MEETING: REGULAR MEETING OF THE PLAN COMMISSION

DATE & TIME: Monday, November 11, 2024 at 6:30 PM

LOCATION: Germantown Village Hall Board Room
N112 W17001 Mequon Road

SHEET 3 OF 5

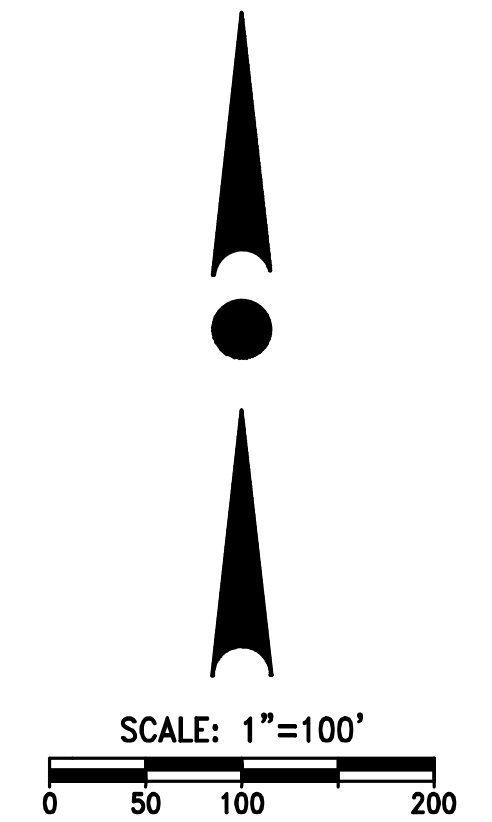
s. 236.20 (2) (c) The 676.00' block length must be shown along the east line of Outlot 6/Outlot 7 on sheet 3.

SHEET NO:
C1.02

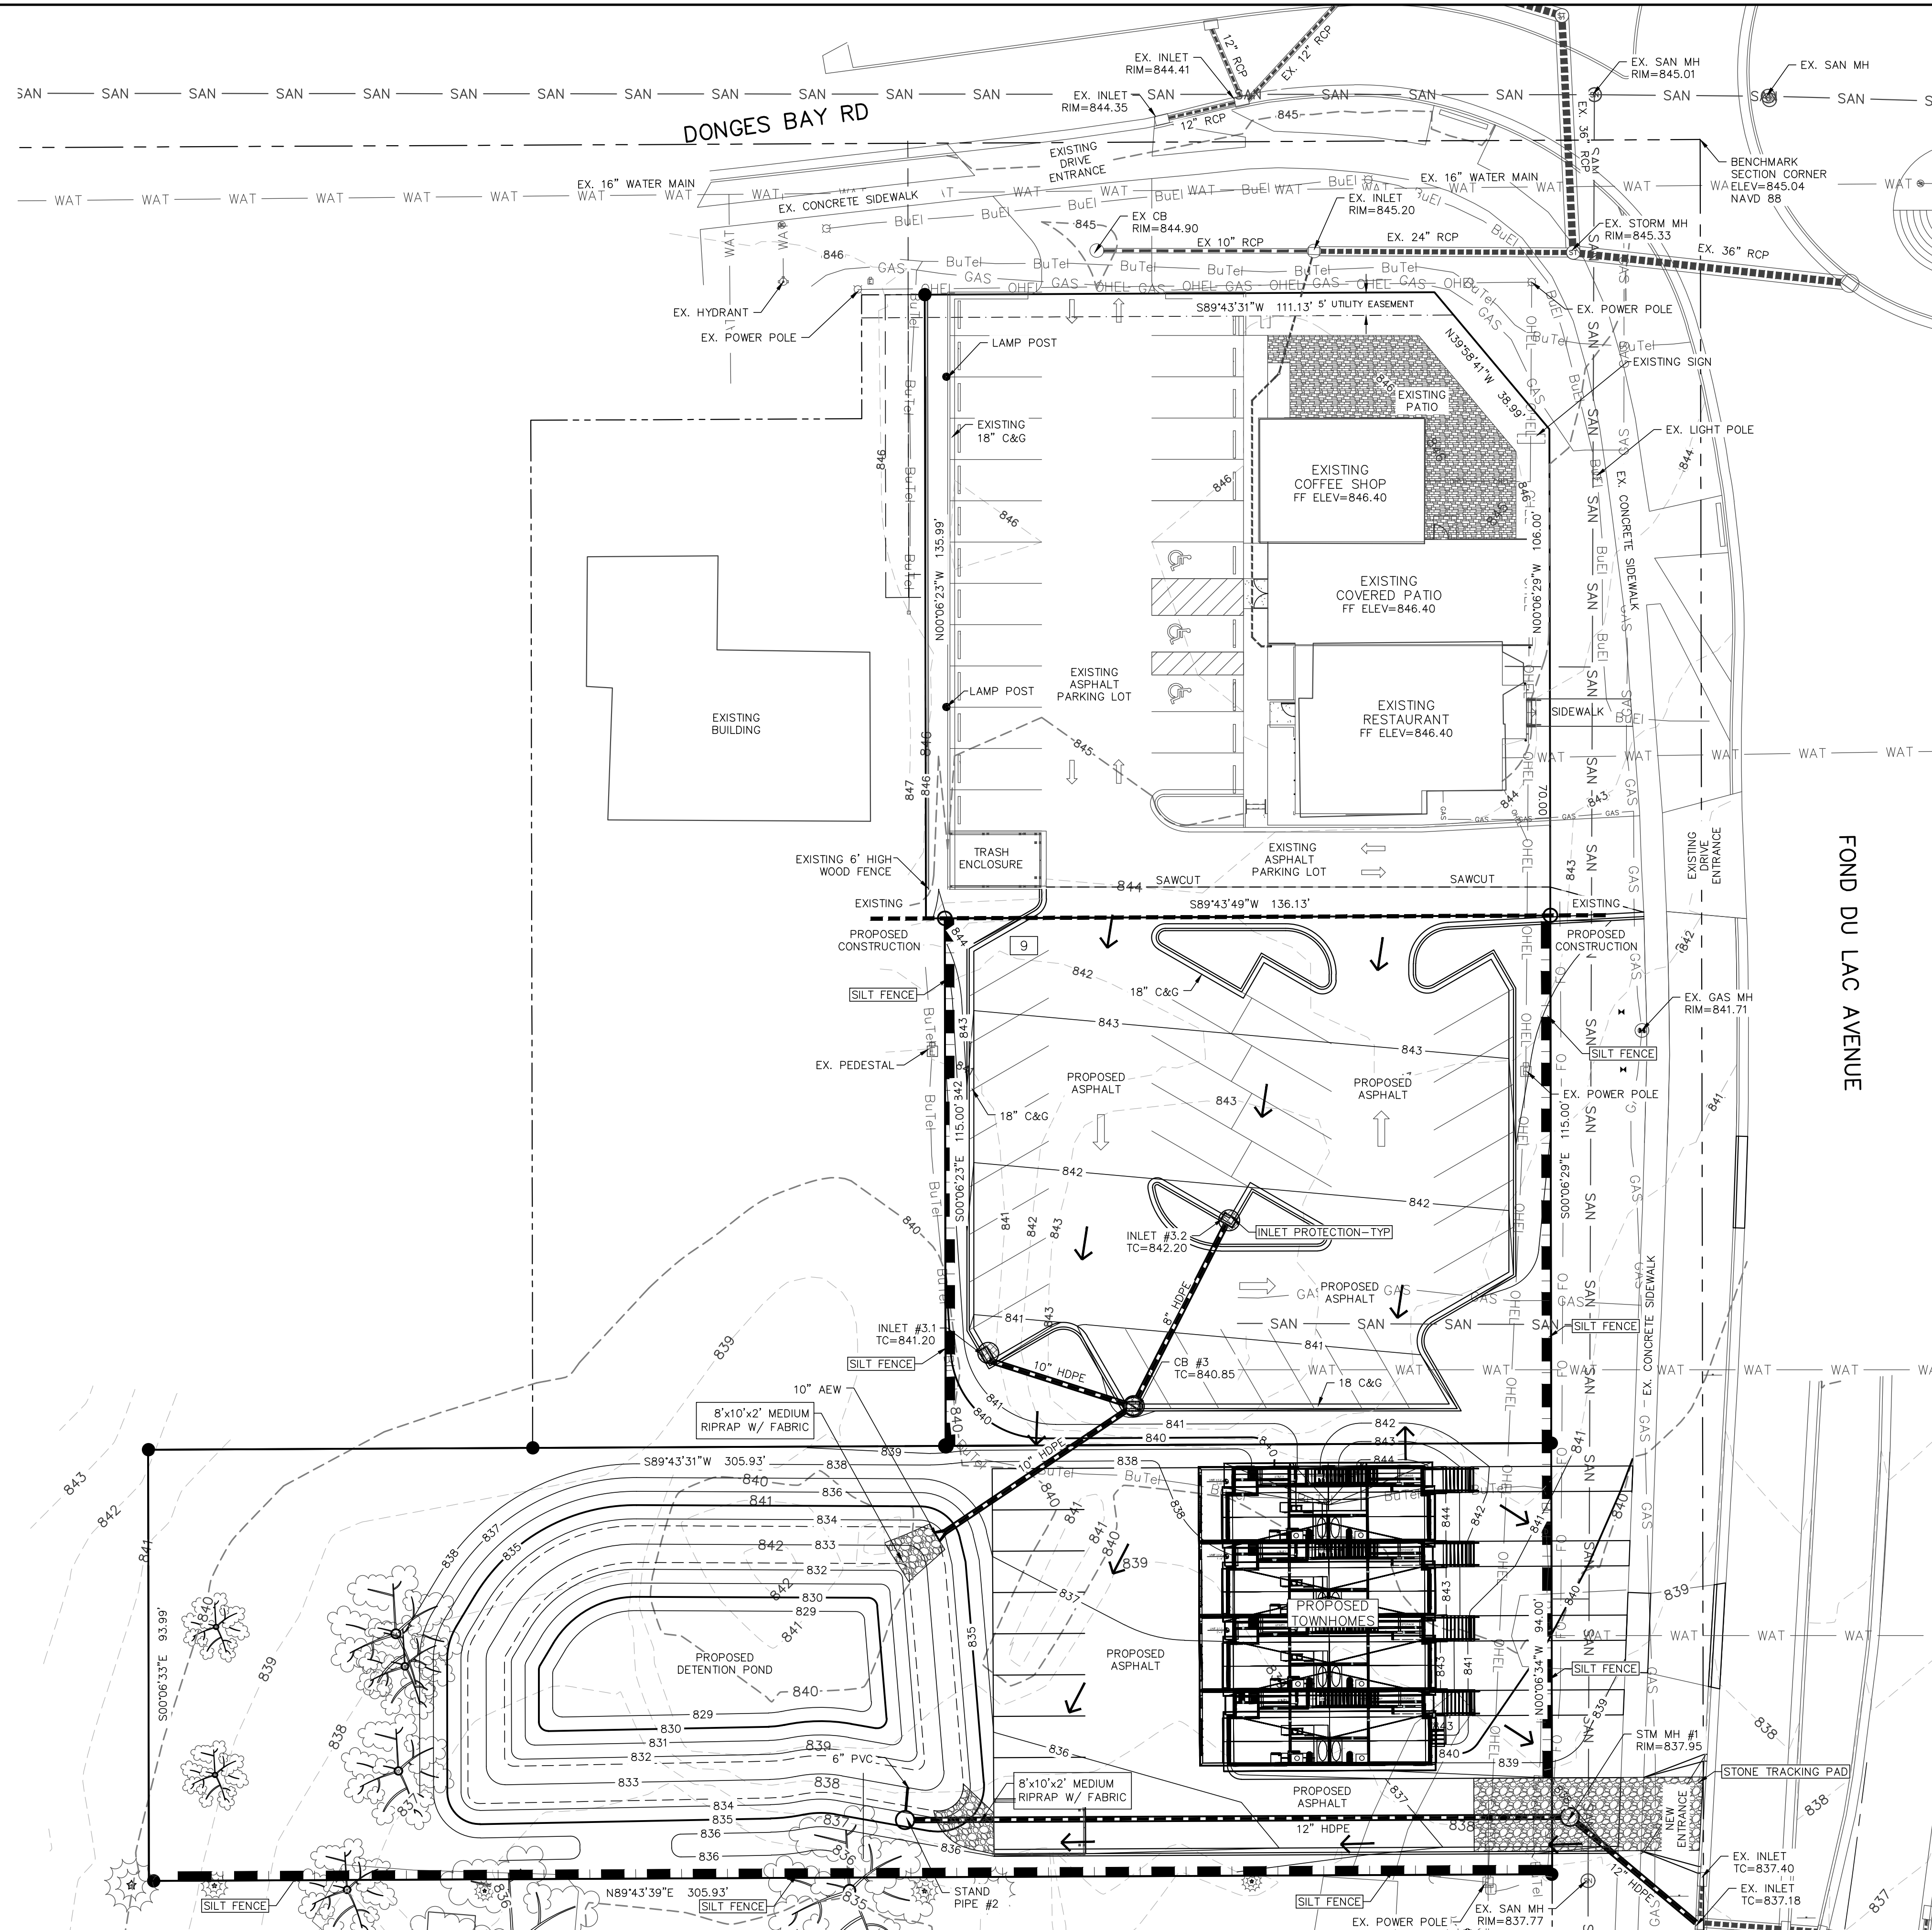
As shown on Sheet C1.02, the proposed setback from the townhouse building to the north property line (proposed parking lot property line) is only 5 feet. Again, a building setback of only 5 from the property (an additional 7 feet to the parking lot pavement edge) leaves little space to provide an adequate landscape buffer to the proposed commercial parking lot serving the proposed renovated restaurant (existing bar).

SHEET NO:
C1.04

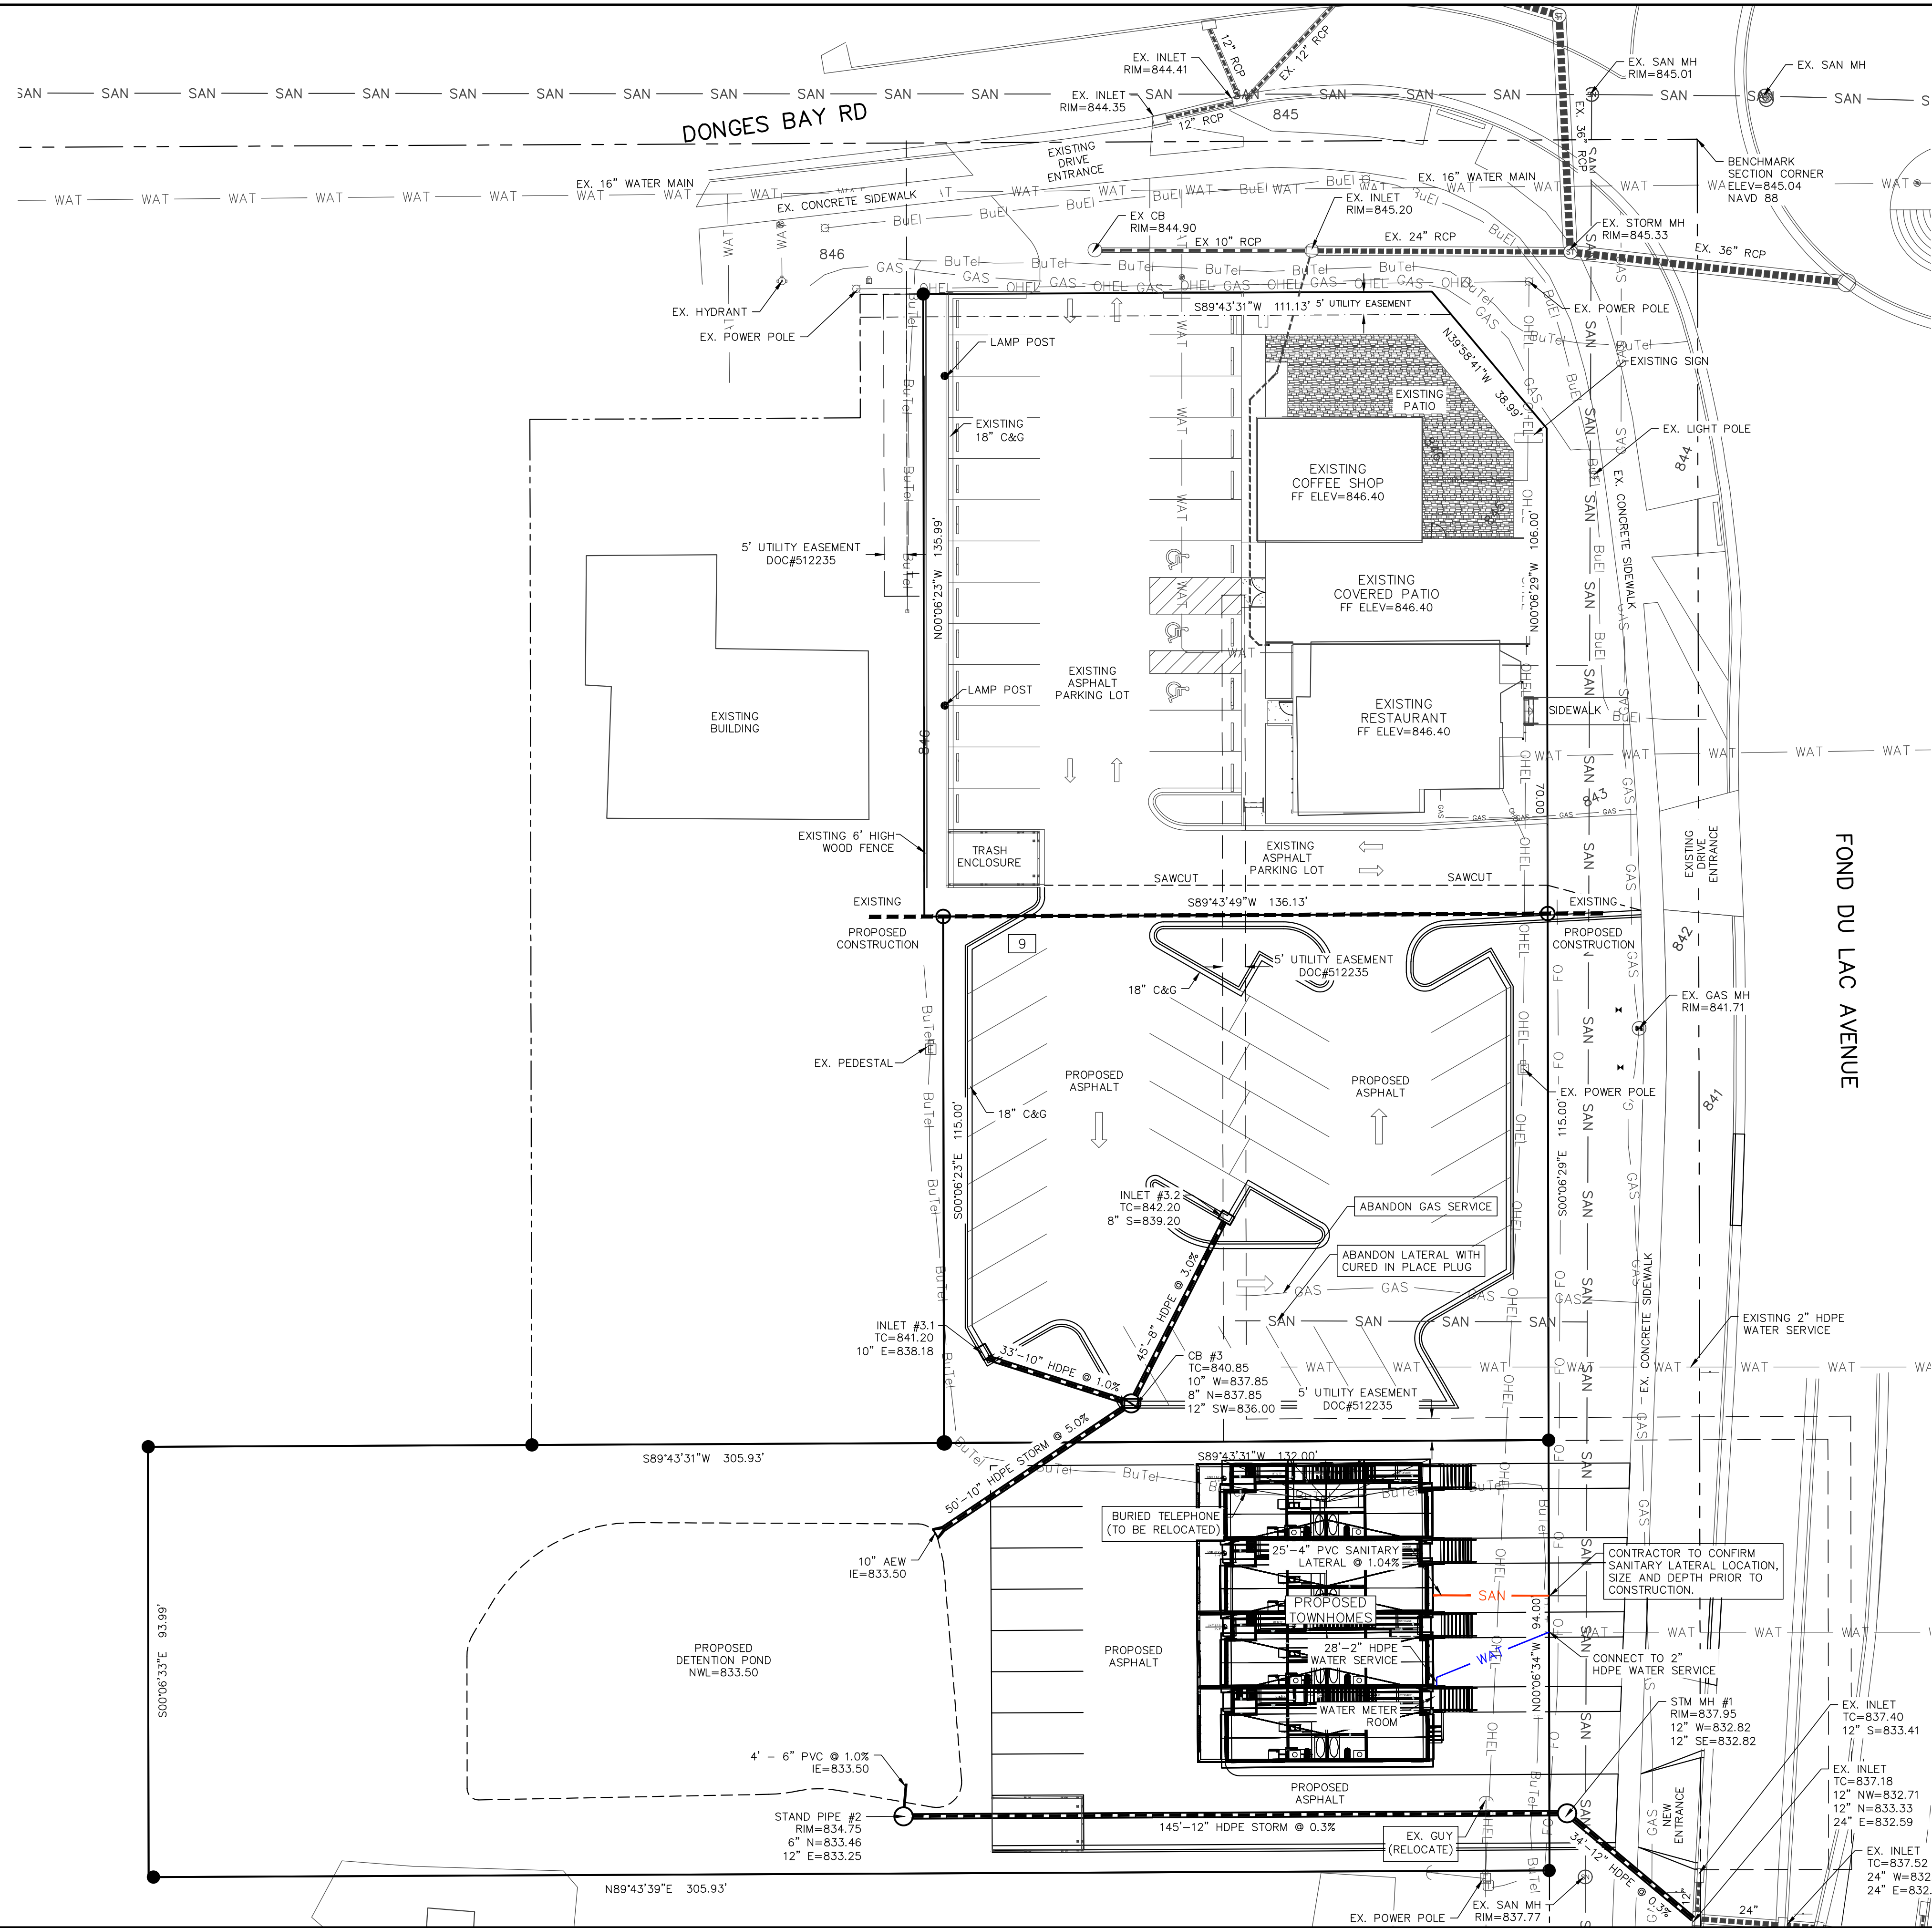
1. Provide elevations for the top and bottom of the proposed steps. **Clarify top of step elevations. Is there another step right at the door?**
2. Recommend adding addition steps to get the slope of the sidewalks under 5%
